SUBJECT: Forwards open items from Structural Engineering Branch
 811005-08 meeting in Woodbury, NY.

Subject: NUCLEAR PROJECT NO. 2
OPEN ITEMS FROM SEB MEETING

Attached are sixty copies of the open items from the Structural Engineering Branch meeting held in Woodbury, New York, October 5 - 8, 1981.

WNP-2
NRC-SEB MEETING

FIGURE
3.2-48

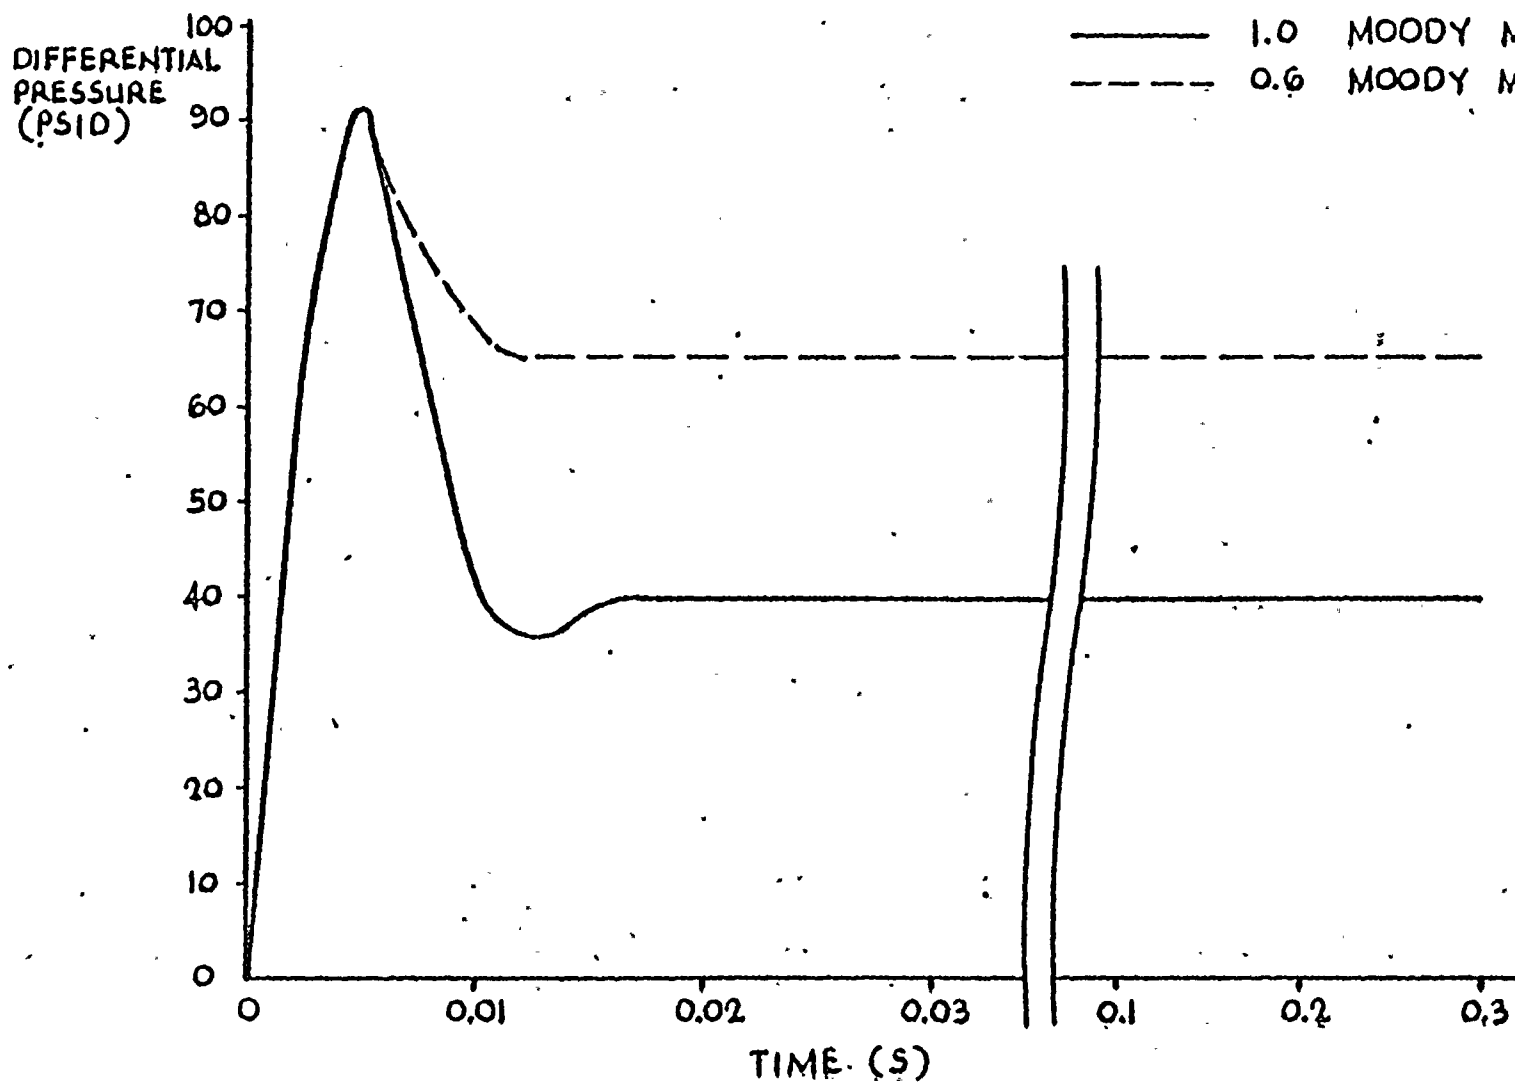
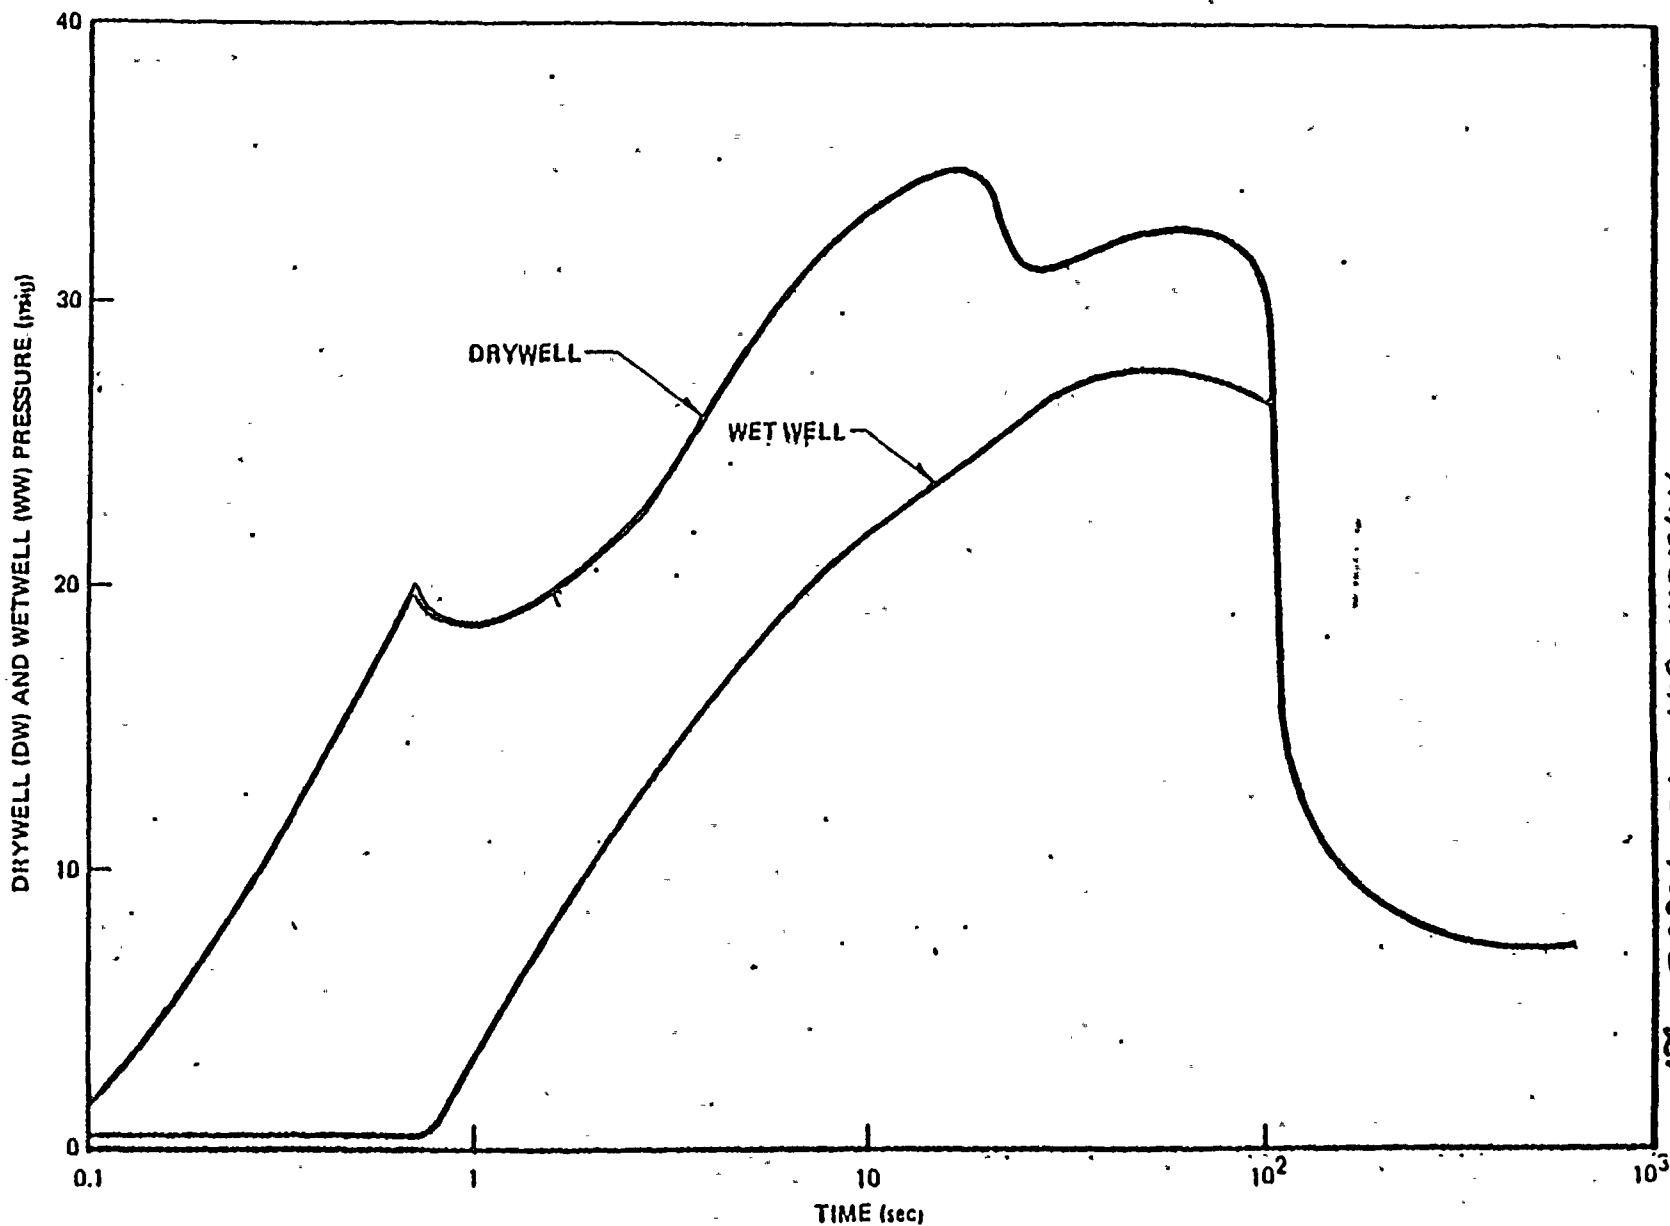
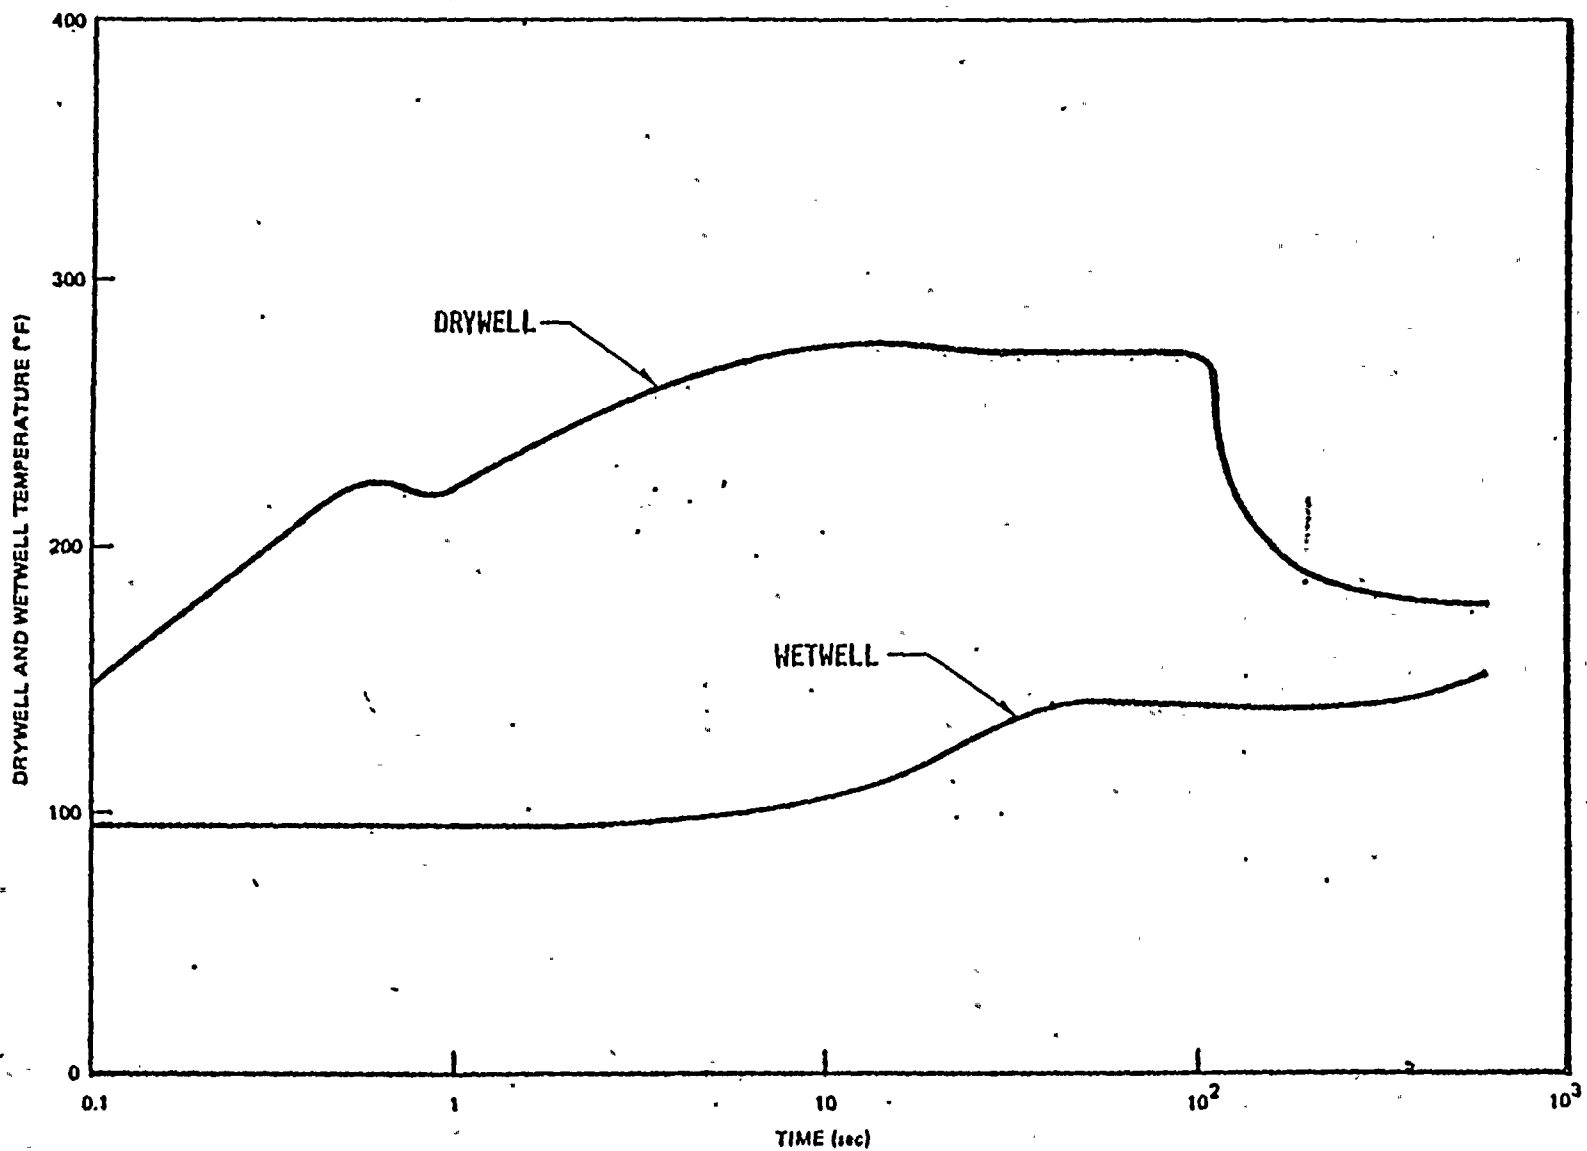
- a. Figure 19, entitled "24 Inch Recirculation Line Node 1", is attached. This figure shows a typical short term time history of the pressure P_a in the annular space. It is seen that the peak dynamic pressure, which controls in design, occurs in less than 0.01 seconds. After the pressure peak, the pressure drops substantially to an interim steady state value. Although the pipe reaction Y_r is not pictured it is known that its basic time history characteristics are similar to those of P_a .
- b. Figure 3.2-48, entitled "Large Recirculation Line Break-Pressure Response-Minimum ECCS", is attached. This figure shows the pressure in the drywell indicating that the main pressure pulse has a duration of about 100 seconds. One can derive from the figure that after 100 seconds, pressures generally have decreased to values which are small compared to the peak dynamic pressure.

- c. Figure 3.2-50, entitled "Large Recirculation Line Break-Temperature Response", is attached. This figure, which pictures the temperature response in the drywell, shows that the duration of the temperature rise is about 100 seconds. It is also evident from the figure that at the time of occurrence of the design pressure and pipe reaction, no substantial rise in drywell temperature has occurred.
- d. An analysis was made to determine the change in temperature in the RPV pedestal due to the LOCA. It is evident that the greatest change can be expected at the end of the temperature rise in the drywell. However, it was concluded that because of the short duration of the accident transient (about 100 seconds) and the low thermal conductivity of the concrete pedestal very little temperature rise would result.

In summary, it is seen that the controlling design loads P and Y due to LOCA occur almost instantaneously after the pipe break. At that time, the thermal load T is effectively non-existent. Even at the end of the drywell temperature rise, the very small temperature increase in the pedestal results in insignificant thermal load. On this basis, omission of T from the significant load terms in the load combination is justified.

ISSUE #33

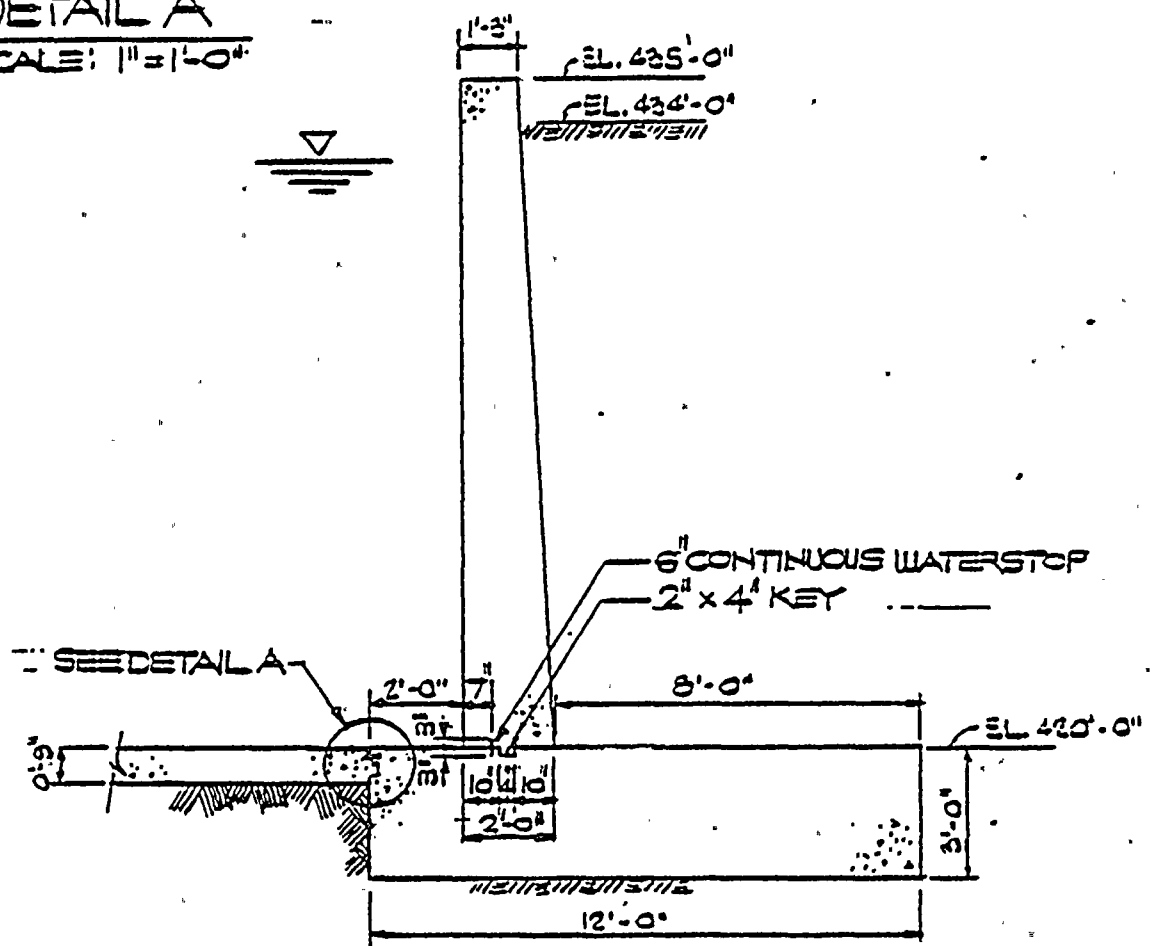
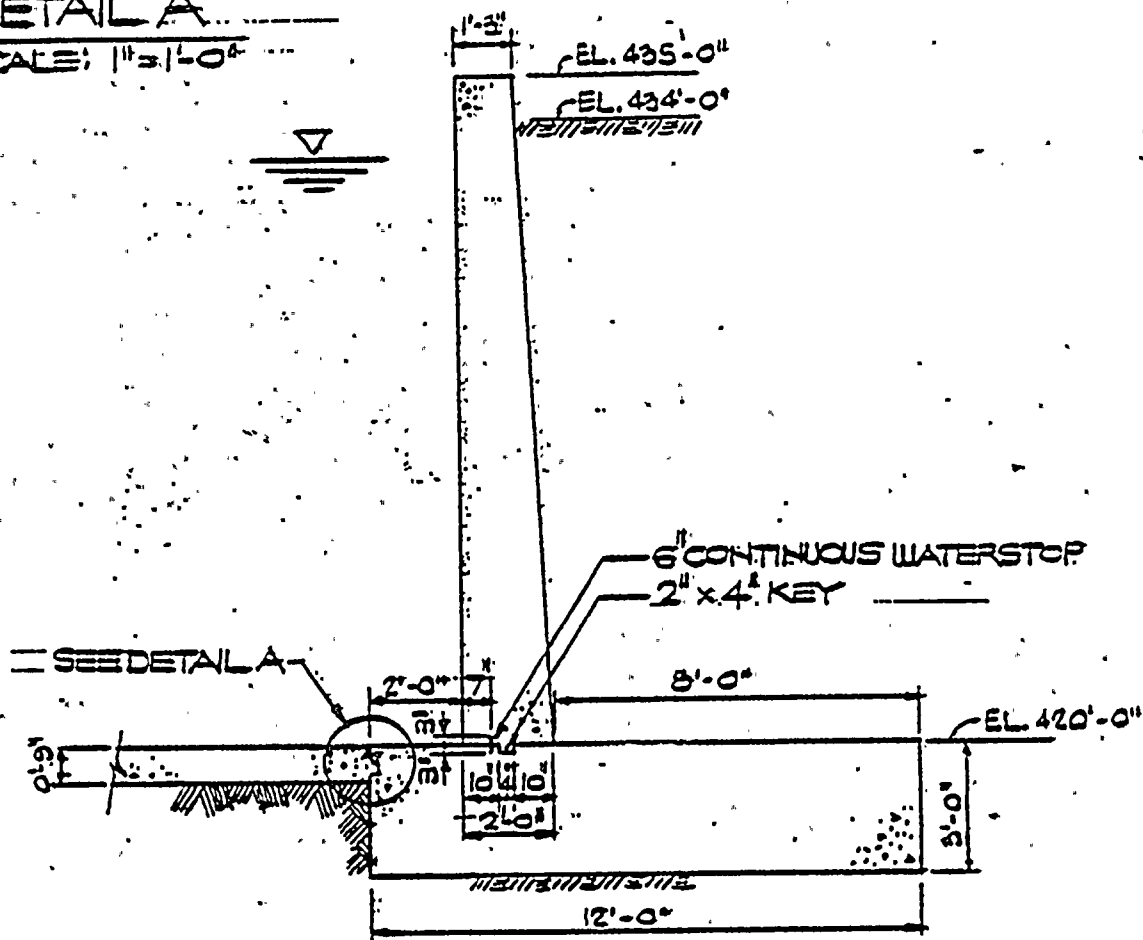
Demonstrate the conservatism of water leakage in spray pond due to the lack of structural continuity (Dwg, S-513 Detail D208).
